**Town of Newbury  
Building Project Construction Committee Friday June 21, 2019  
7:00A.M., at Town Hall**

Martha Taylor, Planner  
Town of Newbury  
25 High Road  
Newbury, MA 01951

Re: Site Plan Review  
Newbury Police Station

As you are aware, Mr. Joseph Serwatka, PE has reviewed the Planning Board Submission plan package, Drainage Analysis and the Site Plan Review Application package, all dated May 15, 2019. In response to the review items noted in the June 3, 2019, we provide the following:

WOOD GUIDE RAIL - METAL POSTS

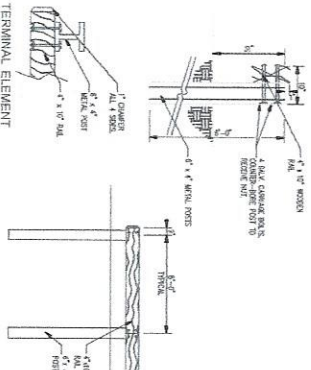
1. A “wood guide rail-metal posts” detail is provided on the plan. The detail should state whether it is a MassDOT standard spec, or other acceptable design.
2. A typical modular retaining walls section is provided. Given the maximum height, about 8 feet, a structural stamp will be required on the wall design. The town may want the engineer to verify that this will be the contractor’s responsibility.

1. A "wood guide rail-metal posts" detail is provided on the plan. The detail should state whether it is a MassDOT standard spec, or other acceptable design.

**The response appears to indicate that the guide rail is not a MassDOT standard, and is intended as a "guide and barrier to prevent parking vehicles from exceeding the paved and curbed surface". The board may want to consider the guide rail suitable for the purpose.**

GGD Response: *The Guide Rail at the end of the four parking spaces northeast of the proposed building is not designed to fully meet current MassDOT guardrail standards. The posts and rails are meant as a guide and barrier to prevent parking vehicles from exceeding the paved and curbed surface. The 6"x4" metal posts do meet MassDOT standard spec per MassDOT Drawing Number 400.1.4, last updated October 2017 with standard depth, however, the rails, 4"x10" timber, is no longer acceptable by MassDOT for highway projects.*

TYPICAL MODULAR RETAINING WALL SECTION

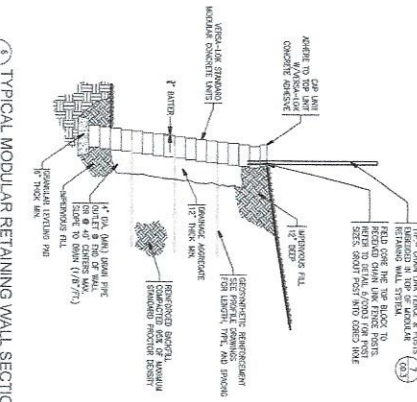
2. A typical modular retaining walls section is provided. Given the maximum height, about 8 feet, a structural stamp will be required on the wall design. The town may want the engineer to verify that this will be the contractor's responsibility.

**The response appears to agree with the recommendation.**

GGD Response: *It will be the responsibility of the Contractor to furnish a signed and stamped calculation report completed by a Massachusetts Registered Professional Engineer as part of the shop drawing review process.*

1 TYP. TRENCH SECTION FOR WATER & GAS  
30.4 M.T.S.

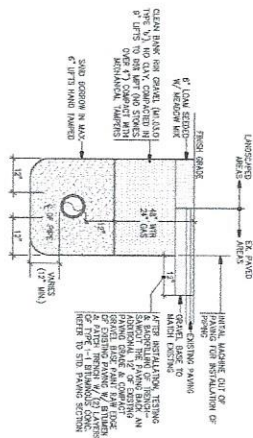
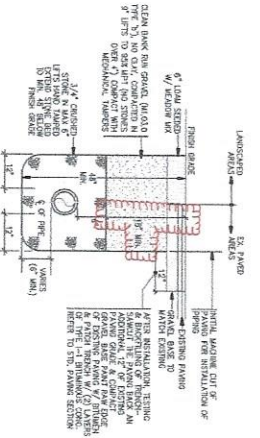
1. The typical trench section for drainage & sewer should provide minimum depths of cover for the respective utilities.

1. The typical trench section for drainage & sewer should provide minimum depths of cover for the respective utilities.

**The detail has been revised to show a minimum depth of cover of 2 feet.**

GGD Response: *A minimum depth of cover will be added to Detail 2/C0.4. Generally, a minimum of two feet of cover is provided to maintain H-20 load rating of the piping. The Contractor shall follow the inverts and rim elevations provided on Schedule 2/C2.1.*

7.2 SITE LAYOUT & MATERIALS PLAN  
SCALE: 1" = 20'

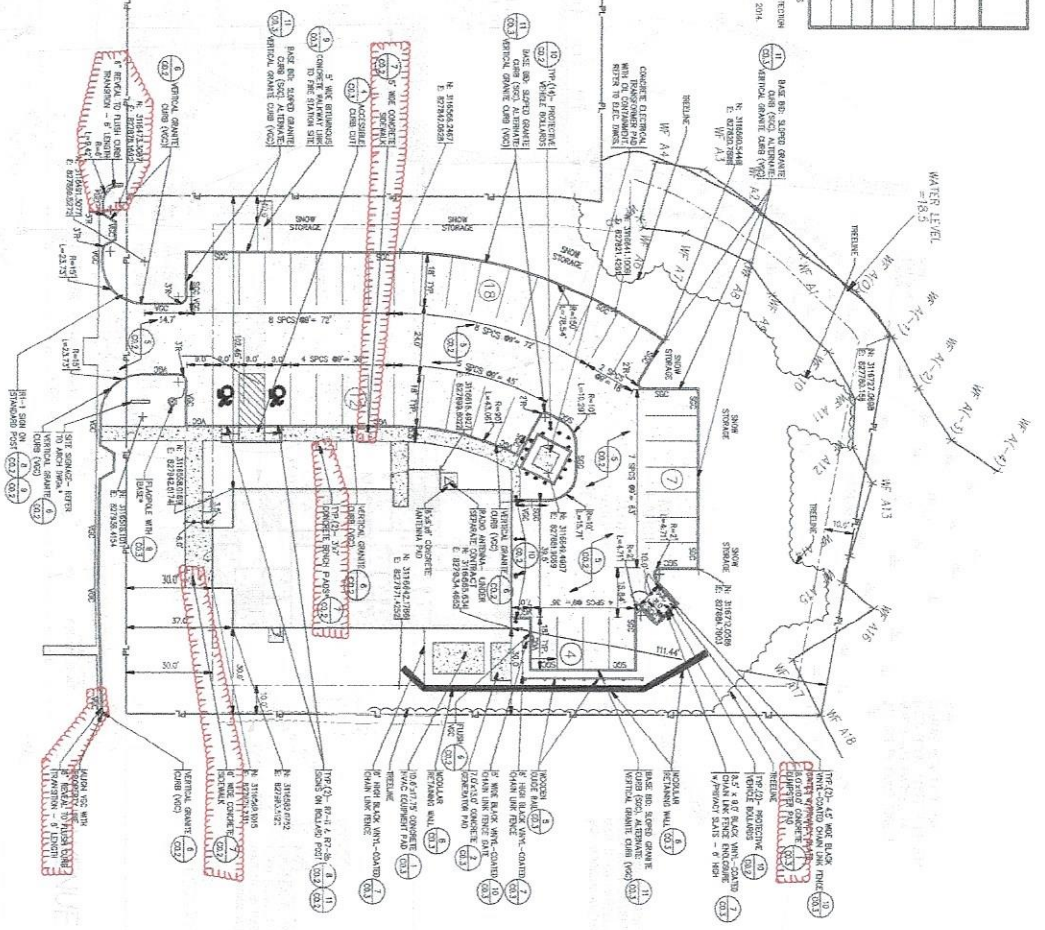
1. The 5.5' wide concrete sidewalk should refer back to detail 7 on sheet C0.2.
2. The site sidewalk extends to Morgan Avenue, and abruptly ends at a proposed vertical granite curb, without a ramp or connection to other sidewalks. The town may want to consider whether sidewalk will ever be installed on the north side of Morgan Avenue.

5. The plan notes a "bituminous concrete dumpster area". Typically, dumpster pads are concrete to withstand the weight and legs of the dumpsters. The town may want the specification revised.

1. The 5.5' wide concrete sidewalk should refer back to detail 7 on sheet C0.2.

5. The plan notes a "bituminous concrete dumpster area". Typically, dumpster pads are concrete to withstand the weight and legs of the dumpsters. The town may want the specification revised.

**The plan has been revised.**

**The plan has been revised.**

GGD Response: *Additional notation on the five foot wide concrete sidewalk west of the proposed structure will be identified with tagging to Detail 7/C0.2*

GGD Response: *Drawings have been revised to include a concrete pad for the dumpster area.*

**1 SITE UTILITY PLAN**  
SCALE 1" = 2'

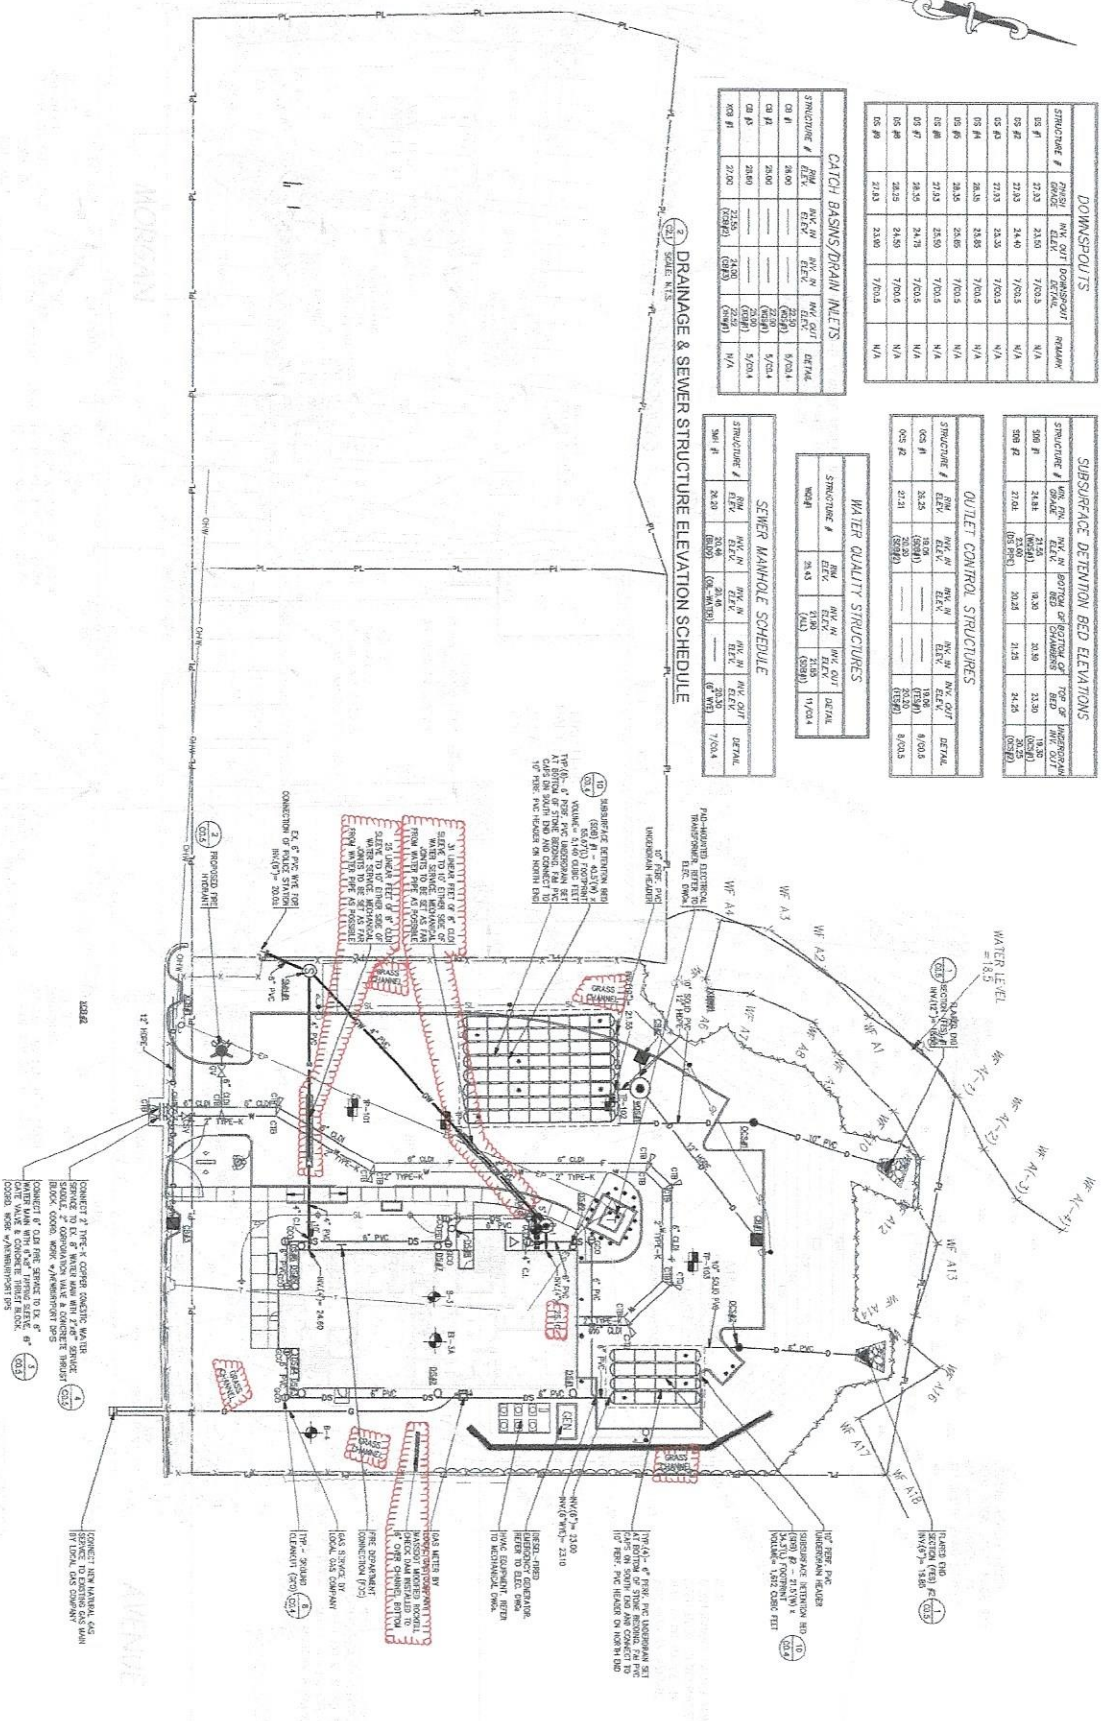
1. The engineer should verify whether the sewer/water crossings depicted comply with general note 13 on sheet C0.1 relative to pipe materials.
2. There appears to be a conflict between the downspout drain and the sewer between DS#8 and DS#9. The engineer should review this.

4. Given the existing inverts and length of the existing 12" CMP along the westerly property line, there may be just an inch or two of clearance between it and the proposed 4" sewer services. If the existing drain is not true to line and grade, or has deflected, there could be a direct conflict. It would be wise to conduct an exploratory test pit at the beginning of site work, at the proposed crossing, to verify any conflicts.

5. The town may want the engineer to address whether the roof runoff could be added to subsurface detention bed (SDB) #1, and possibly eliminate the need for SDB #2. This may result in considerable cost savings to the town, and eliminate one of the two pipe outfalls.

6. A Stormceptor water quality structure is included in the runoff treatment train for the pavement runoff. This is a proprietary unit that provides for 75% TSS removal based on the TSS worksheet. The engineer has taken the typical 25% TSS removal credit for the deep sump catchbasins, but has not taken credit for the subsurface detention structures, which may provide 80% TSS removal based on the DEP literature. Taking the allowable credit for the SDBs may allow the engineer to remove the Stormceptor unit, which is a fairly expensive item that requires specialized maintenance/pumping. The engineer may also be able to take credit for the street sweeping outlined in the maintenance schedule. The town may want the engineer to comment on these ideas.

1. The engineer should verify whether the sewer/water crossings depicted comply with general note 13 on sheet C0.1 relative to pipe materials.

4. Given the existing inverts and length of the existing 12" CMP along the westerly property line, there may be just an inch or two of clearance between it and the proposed 4" sewer services. If the existing drain is not true to line and grade, or has deflected, there could be a direct conflict. It would be wise to conduct an exploratory test pit at the beginning of site work, at the proposed crossing, to verify any conflicts.

5. The town may want the engineer to address whether the roof runoff could be added to subsurface detention bed (SDB) #1, and possibly eliminate the need for SDB #2. This may result in considerable cost savings to the town, and eliminate one of the two pipe outfalls.

6. A Stormceptor water quality structure is included in the runoff treatment train for the pavement runoff. This is a proprietary unit that provides for 75% TSS removal based on the TSS worksheet. The engineer has taken the typical 25% TSS removal credit for the deep sump catchbasins, but has not taken credit for the subsurface detention structures, which may provide 80% TSS removal based on the DEP literature. Taking the allowable credit for the SDBs may allow the engineer to remove the Stormceptor unit, which is a fairly expensive item that requires specialized maintenance/pumping. The engineer may also be able to take credit for the street sweeping outlined in the maintenance schedule. The town may want the engineer to comment on these ideas.

**The plans have been revised to comply with note 13.**

**The plan has been revised to address this issue.**

**The response appears to state that this option was reviewed but ruled out due to site constraints.**

**The engineer has added the proprietary separator to prevent clogging of the underground system.**

GGD Response: *The two water and sewer crossings have been reviewed and updated to reflect the sewer being sleeved with mechanical joint piping due to the sewer crossing over the water line.*

GGD Response: Based on our interpolation, it is expected that there should be approximately four to six inches of separation from the top of the sewer pipe to the bottom of the existing drain pipe. A note will be added to the Site Demolition & Preparation Plan calling for the contractor to perform a test pit at the crossing location and report bottom of pipe elevation prior to proceeding with the sewer installation.

GGD Response: The consolidation of Subsurface Detention Beds (SDB) #1 and #2 was reviewed prior to submission. Due to site constraints (drainage structures, water, electrical and sewer services), the footprint of Subsurface Detention Bed #1 cannot be sufficiently expanded to provide the volume of storage that Subsurface Detention Bed #2 can provide.

GGD Response: Volume 2, Chapter 2: Structural BMP Specifications for the Massachusetts Stormwater Handbook outlines Total Suspended Solids (TSS) removal efficiencies for stormwater structural Best Management Practices (BMPs). The Stormwater Handbook does allow 80% TSS removal for Subsurface Structures that infiltrate, however, the proposed system is for detention purposes due to the high groundwater and site fill materials. We recommend the installation of the hydrodynamic water quality separator unit to prevent fine suspended solids from entering the Subsurface Detention Beds and clogging the voids in the storage volume over time.
